# UNITED STATES PATENT AND TRADEMARK OFFICE

APPLICATION NO.	FILING DATE	FIRST NAMED INVENTOR	ATTORNEY DOCKET NO.	CONFIRMATION NO.
10/806,125	03/23/2004	Takahiro Tsuchiya	119200	2123
25944	7590	11/29/2005		
OLIFF & BERRIDGE, PLC P.O. BOX 19928 ALEXANDRIA, VA 22320			EXAMINER CHANDRAN, BIJU INDIRA	
			ART UNIT 2835	PAPER NUMBER

<b>Office Action Summary</b>	<b>Application No.</b> 10/806,125	<b>Applicant(s)</b> TSUCHIYA ET AL.	
	<b>Examiner</b> Biju Chandran	<b>Art Unit</b> 2835

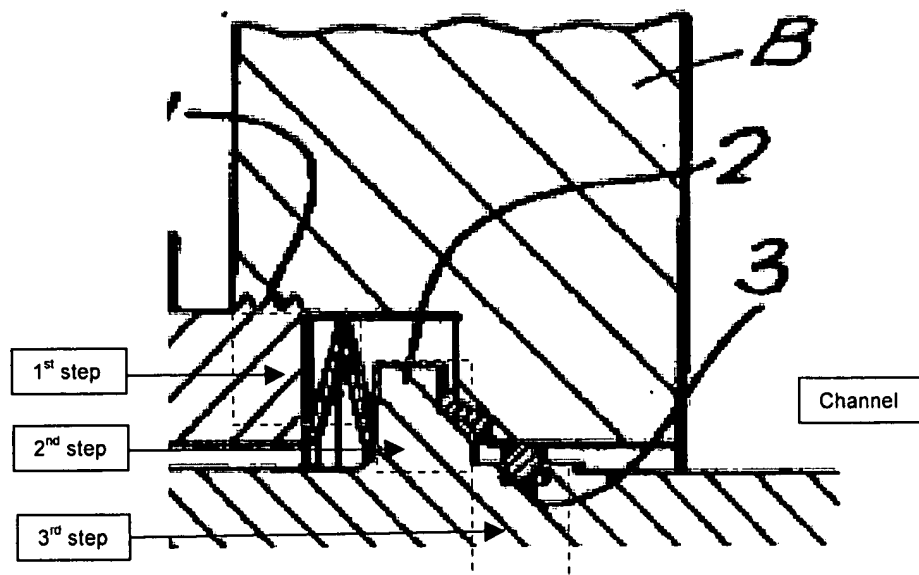
- Regarding claim 1, Suzuki et al. disclose a watertight plate including a channel sidewall which contact with a cover plate demarcate a channel, wherein, on the channel sidewall a resin lump (10), of the sealing resin is housed. While Suzuki et al. do not explicitly say that the seal is made of resin, they do indicate that the seal (10) may comprise gaskets composed of laminated or combined rubber, compounds, metals or O rings (paragraph 0031), some of which falls within the definition of 'resin' (Academic Press Dictionary of Science

and Technology defines resin as: Any one of several solid or semisolid natural or synthetic organic products, usually translucent polymers that do not conduct electricity; used in plastics, textiles, paints, and varnishes). Suzuki et al. do not disclose step portions on the channel sidewall housing the sealing resin. Gunn et al. (figure 2) disclose a channel sidewall which contact a cover plate demarcating a channel, and formed on the channel are: a first step portion in contact with the cover plate; a second step portion which is closer to the channel and lower than the first step portion and is applied with a sealing resin; and a third step portion which is closer the channel and lower than the second step portion and within which the sealing material is housed.

- Regarding claim 2, Suzuki et al. disclose a power supply device (paragraph 0006) including a watertight plate with electronic parts including a switching element (301a), a transformer (first four lines of paragraph 0020 which disclose that a function of the enclosed electronic devices is to convert a DC input into an AC output of variable voltage. A device which changes the voltage of an input current is a transformer – paraphrasing from Academic Press Dictionary of Science and Technology) and a rectifier (last three lines of paragraph 0021 which describe that another function of the enclosed electronic devices is to convert AC input from the motor to DC input into the battery. A rectifier is a device that converts alternating current into direct current, according to the Academic Press Dictionary of Science and Technology) mounted thereon, said watertight plate having a channel sidewall contact with a cover plate and demarcating a channel through which a coolant flows for cooling said electronic parts (see attached figure). Suzuki et al. do not disclose step portions on the channel sidewall housing the sealing resin. Gunn et al. (figure 2) disclose a channel sidewall, wherein on the channel sidewall, formed are: a first step portion in contact with the cover plate; a second step portion which is closer the channel and

lower than the first step portion and applied with a sealing resin; and a third step portion which is closer to the channel and lower than the second step portion and within which a resin lump of the sealing resin is housed (see attached figure). At the time of the invention, it would have been an obvious matter to one of ordinary skill in the art, to incorporate the step portions housing the sealing material as taught by Gunn et al. in the watertight plate disclosed by Suzuki et al., to provide a good seal for the channel even in high pressure.

- Regarding claim 3, Suzuki et al. disclose a power supply device including a watertight plate with electronic parts including switching element (301a), transformer (first four lines of paragraph 0020 which disclose that a function of the enclosed electronic devices is to convert a DC input into an AC output of variable voltage. A device which changes the voltage of an input current is a transformer – paraphrasing from Academic Press Dictionary of Science and Technology) and a rectifier (last three lines of paragraph 0021 which describe that another function of the enclosed electronic devices is to convert AC input from the motor to DC input into the battery. A rectifier is a device that converts alternating current into direct current, according to the Academic Press Dictionary of Science and Technology) mounted thereon, said watertight plate having channel sidewall in contact with cover plate with a sealant resin (10) between them (see attached

figure), and demarcating a channel through which coolant flows for cooling said electronic parts. Suzuki et al. do not disclose step portions on the channel sidewall housing the sealing resin. Gunn et al. (figure 2) disclose a channel sidewall, wherein, the first step portion contacts with the cover plate; second step portion which is closer to the channel and lower than the first step portion and is applied with a sealant; and a third step portion which is closer to the channel and lower than the second step portion and within which the sealant is housed (see attached figure); and the channel is demarcated when the sealant is applied onto the second step portion of the watertight plate and the cover plate is brought into contact with the first step portion of the watertight plate. At the time of the invention, it would have been an obvious matter to one of ordinary skill in the art, to incorporate the step portions housing the sealing material as taught by Gunn et al. in the watertight plate disclosed by Suzuki et al., to provide a good seal for the channel even in high pressure.
